SIL 16-WT-20
December 08, 2020
Page 1 of 4

SUBJECT: 3000, 4000 Series Retarder Accumulator – Piston and Seal Improvements

MODELS AFFECTED: 3000, 4000, B300, B400, T200, T300, T400, T500 and B500

Figure 2. Former (Left) Current (Right)

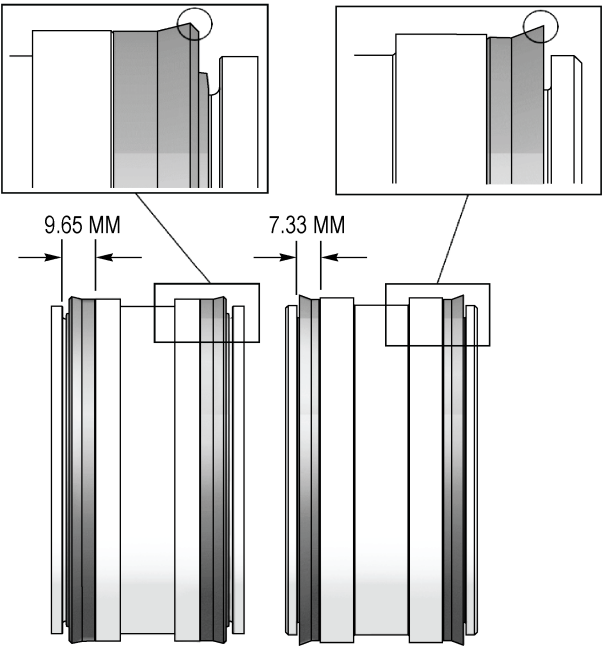
The current Piston Seal is slightly narrower in cross section and the Piston Seal Grooves are slightly narrower to correspond. The lip of the current seal is no longer beveled. See [Figure 2](#).
